Flow Control Division

Subject: Missing Jam Nuts on Size 4, Pressure Class 600 Normally Open, In-Line Check Valve per Flowserve Drawing No. 07-45546-01

Attachment: Flowserve Drawing No.07-45546-01

07-45546-01

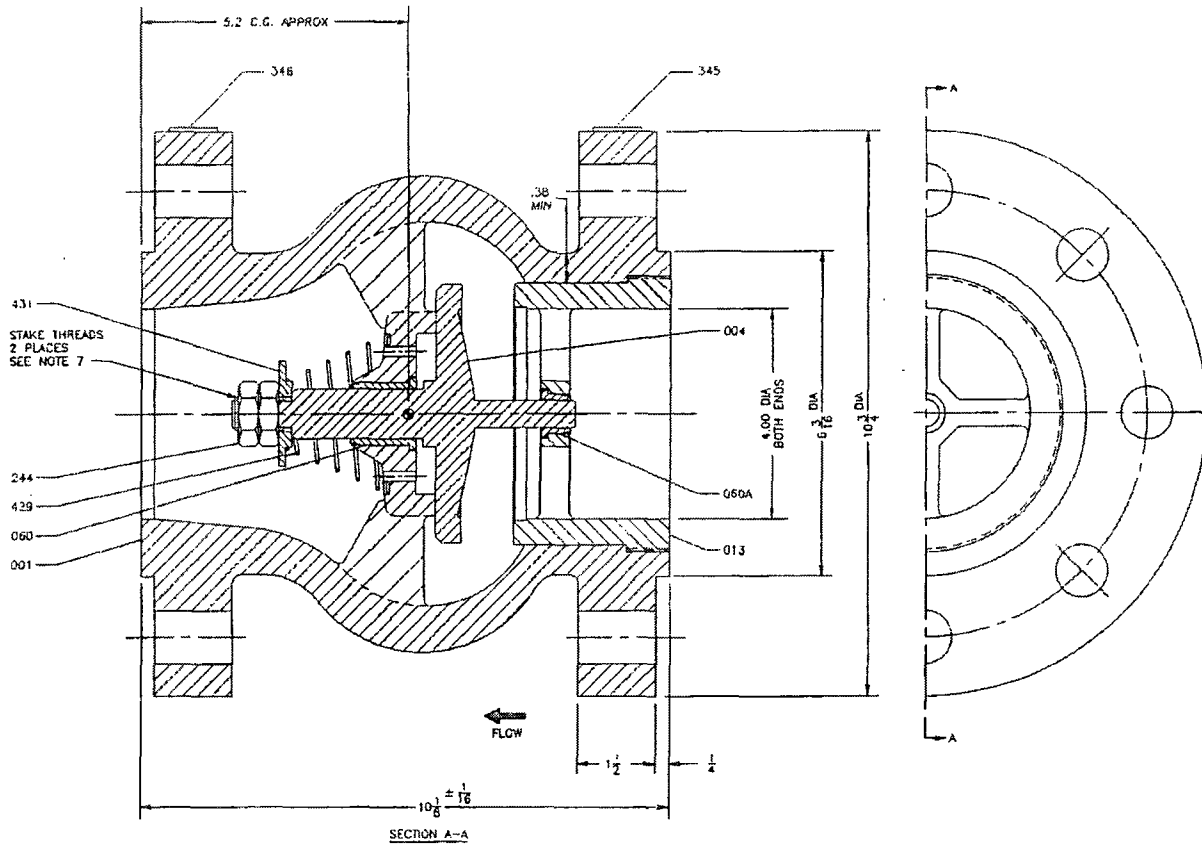
Nature of the Defect: In March of 2014, PG&E Diablo Canyon visual inspection discovered the outer jam nut was missing from the valve stem and was found downstream. This jam nut locks the inner jam nut which retains the spring and spring retainer. There were signs of one stake on the stem threads. These check valves include a conical spring which maintains the disc open in its normal position. Flow in the normal direction maintains the valve open and a minimum reverse flow is required to close the valve. The valve is used in saturated steam service and must close with a reverse flow of less than 7000 lbs/hr steam at 95 and 1085 psig. The PG&E supplied data sheet does not identify a specific safety related function. However, the valve operating parts are identified as safety related on the drawing.

Evaluation: Flowserve has completed an evaluation of the most recent failure and concluded that the root cause of the outer jam nut loosening and unscrewing from the stem, most likely is from inadequate nut tightening and staking. The original assembly drawings for the valves did not specify the required torque value and specified only one stake requirement. Based on the fact that this is the second failure of this type Flowserve no longer considers it to be an isolated incident and that it is reportable under the requirements of 10 CFR 21.

- As noted above after the initial failure, on March 7, 2013, PG&E Diablo Canyon was notified by letter to torque the jam nuts to 44 ftlbs and to stake the threads in two places when reassembling the valve.
- For future reference Assembly Drawings 07-45546-01 and W9925475 which cover the designs of the Diablo Canyon valves and a similar design used for the TVA Sequoyah Plant were revised to add jam nut torque and more detailed thread staking notes.
- In addition to the instructions given on the assembly drawing, in the future Flowserve's internal assembly instructions will include more detail regarding the torquing and staking operations.

Based on the second valve failure, Flowserve recommends that PG&E Diablo Canyon and TVA Sequoyah inspect all in service valves for proper torque and provide dual thread staking per the revised drawings.

- APPROX VALVE WEIGHT = 115 LBS.
- APPROX VALVE Cy = 210.
- VALVES ARE NORMALLY OPEN AND DESIGNED TO CLOSE AT < 7000 LBM/HR REVERSE SATURATED STEAM FLOW AT 85 AND 1085 PSIG.
- ALTERNATE MATERIALS:
A. SA479-316L
5. \odot DENOTES CENTER OF GRAVITY.
- SAFETY CATEGORY:
A. PRESSURE BOUNDARY.
B. SAFETY RELATED.
- TORQUE NUTS TO 44 FT-LBS. STAKE NUT THREADS IN TWO PLACES 90 TO 120 DEGREES APART TO SECURE NUT.
